VEAX LLO Existing Cable Piers Locations

NOTE: This drawing is NOT correct yet. It was made by mirroring the VEAY drawing D1201231-v1. Its ultimate purpose is to show the existing cable tray and piers relative to the as-built IFO.

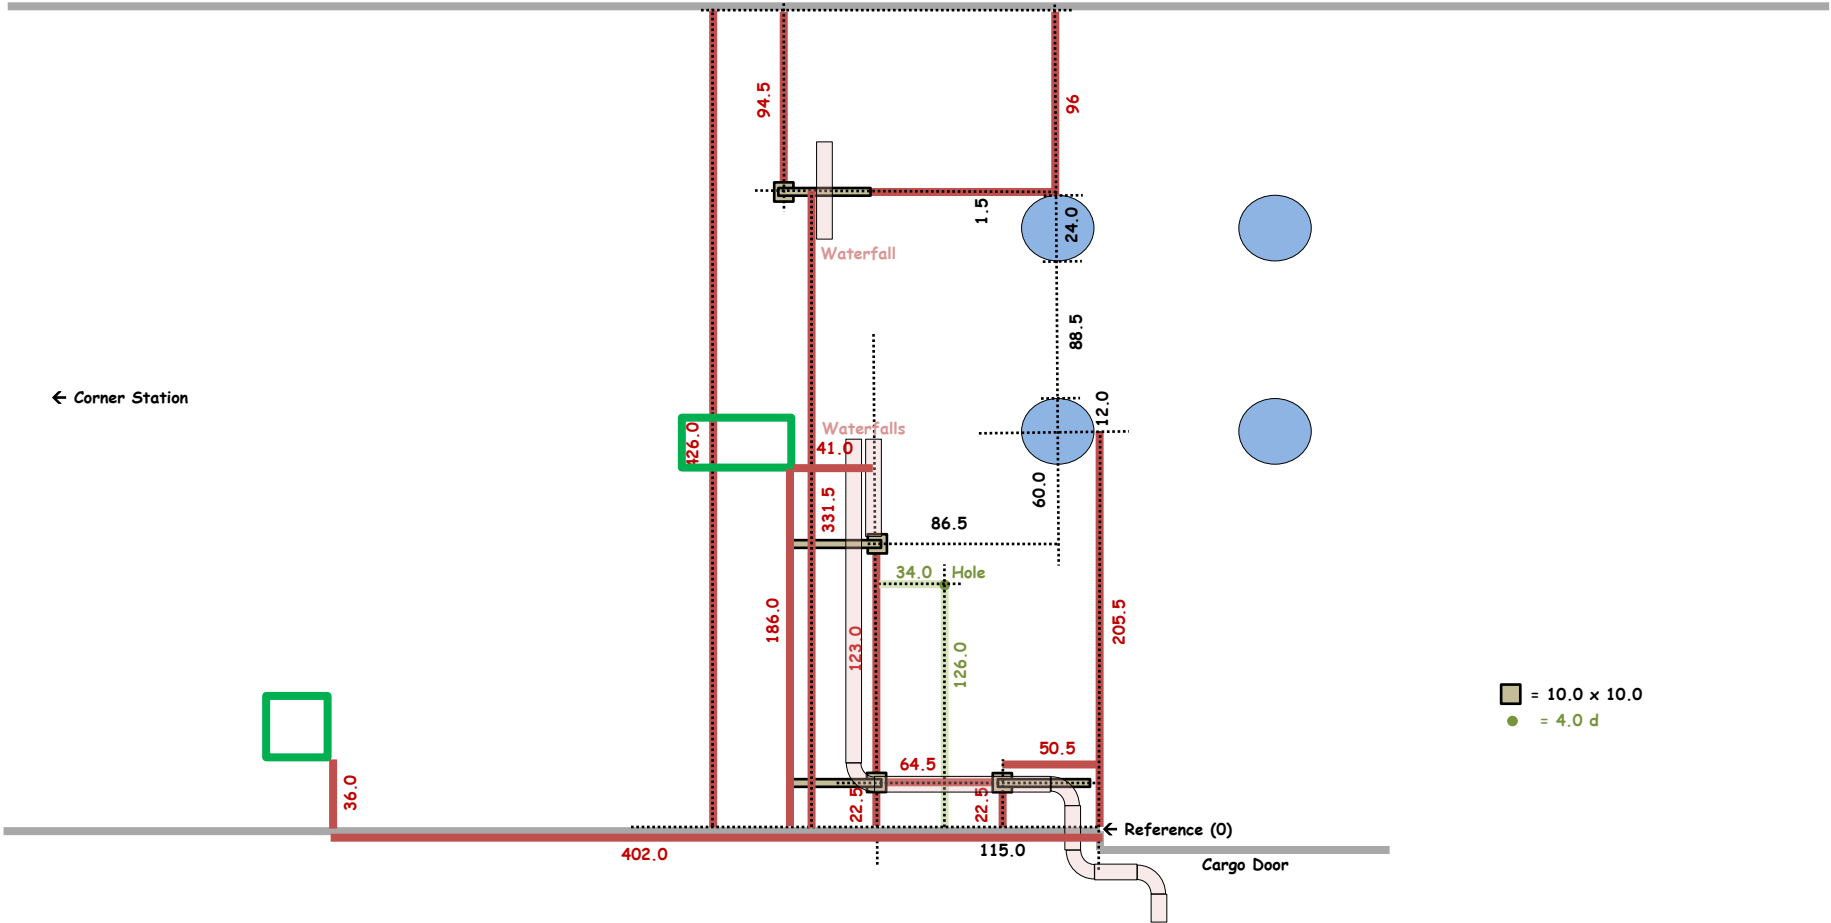
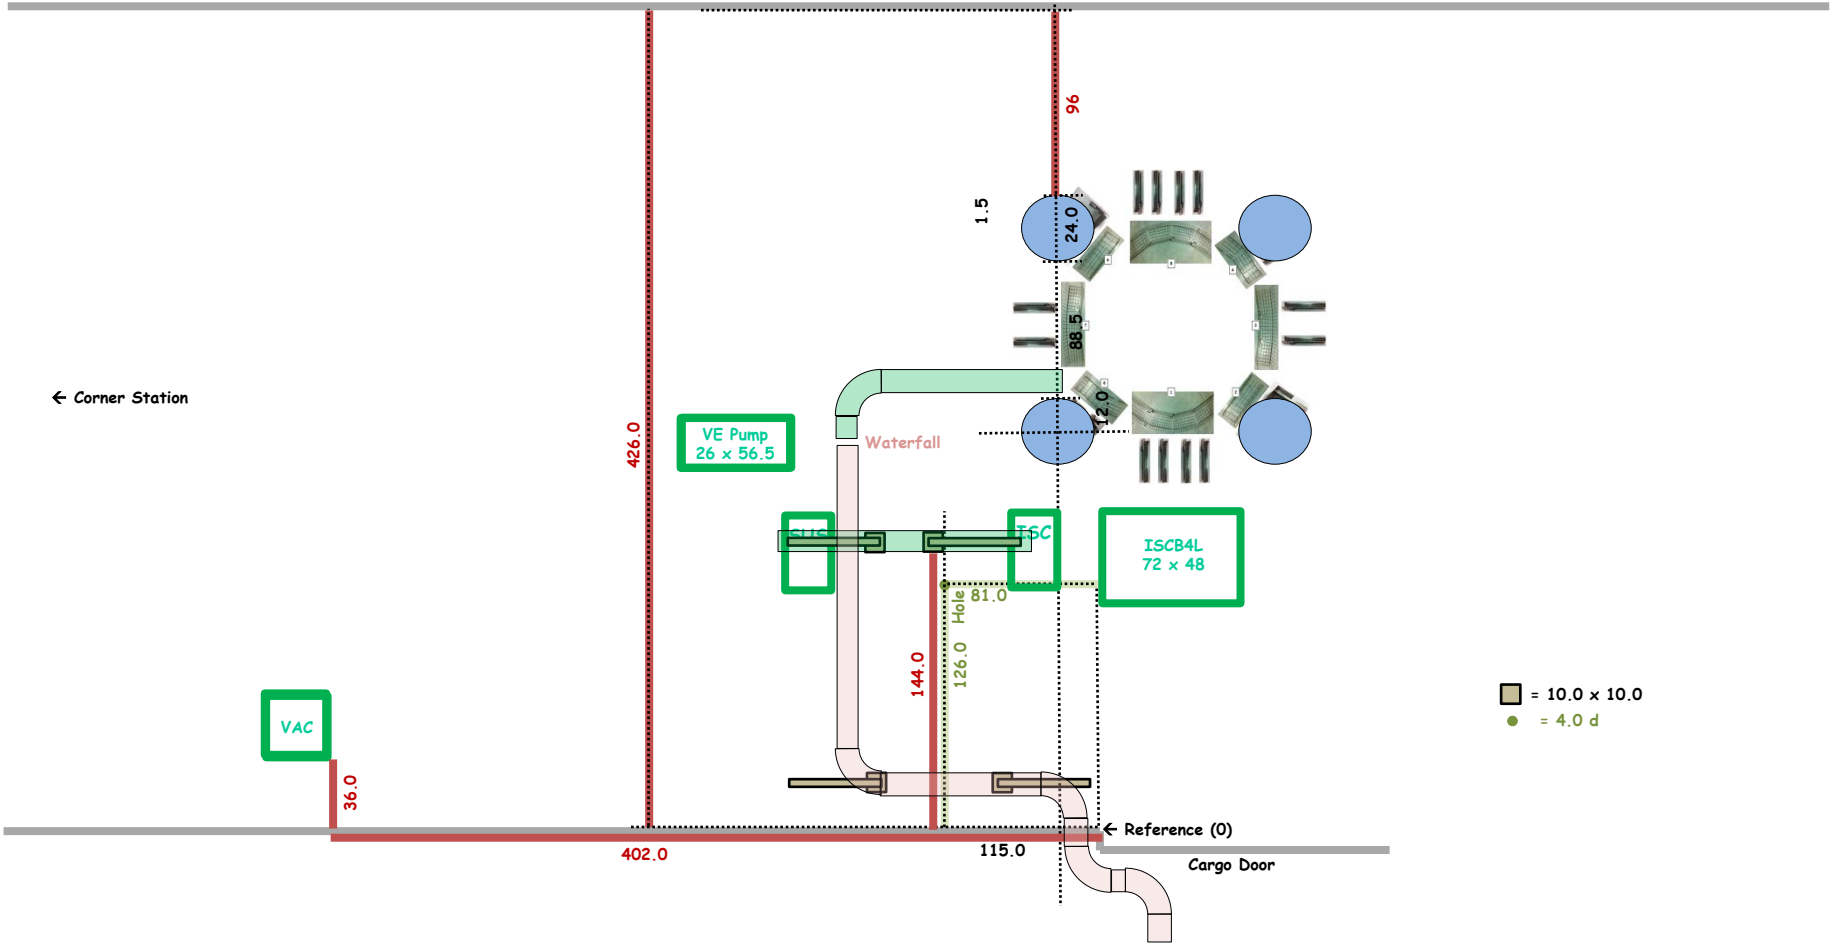
- 1) Where does 11U Short Rack (D1001423-v11) go? (Ignore)
- 2) Where does L1-AOS-XR1 (if it needs to exist) go? (Does not exist)
- 3) What does pentagon-2 mean regarding tray removal? Is there tray across the beam tube from L1-SUS-XR1? (Ignore)
- 4) Is the called-out 10' height important for some reason? LLO height is 8'. (OK)
- 5) What are the double doors in the note all about? (Ignore)
- 6) A door is missing from the garb room to the VEA. (Ignore)
- 7) The doors are missing from the mechanical room. (Ignore)
- 8) L1-VAC-XR1 is missing. (Shown)
- 9) All cabling that currently uses under-beam tray and the waterfall is missing. (Kurt)
- 10) The Photon Calibrator is missing. (Mounted to tube - part of OPLEV)
- 11) VE Pumps are not shown. (Shown)
- 12) Size of ISCB4L is not specified. (72 x 48)

- 1) Remove old cable tray and pier that interferes with dome parking.
- 2) Locate L1-ISC-XR1 farther away from existing pier for clearance.
- 3) Suggest joining basket around BSC to existing cable tray at waterfall.
- 4) Used removed pier to extend cable tray to L1-ISC-XR1.
- 5) Add cable tray to reach L1-SUS-YR1.
- 6) Remove parallel waterfall, move 'T' to primary waterfall.

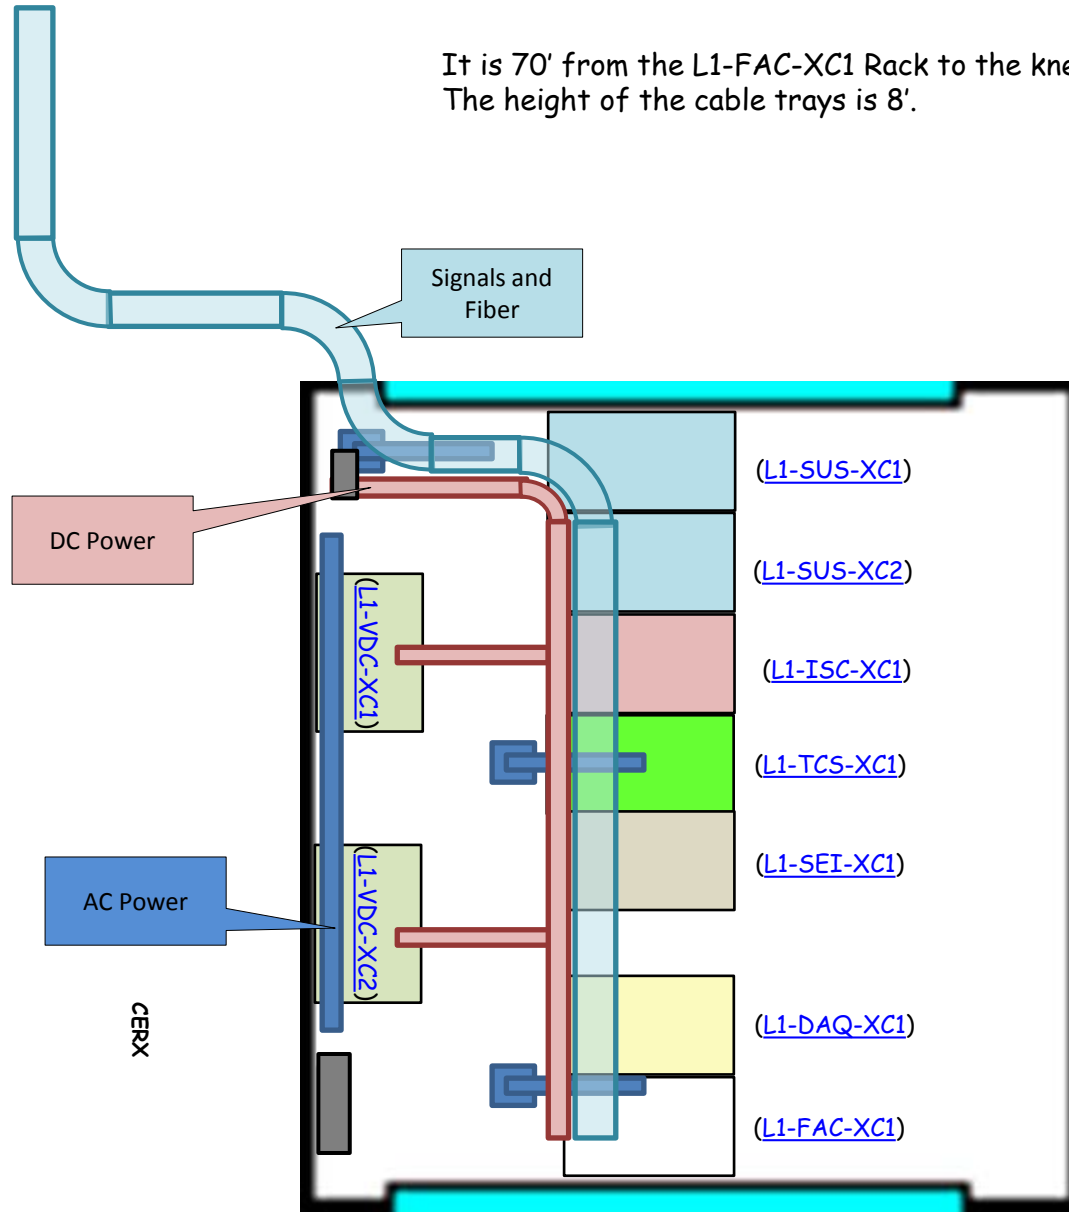
It is 70' from the L1-FAC-XC1 Rack to the knee of the waterfall in the VEAX.
The height of the cable trays is 8'.
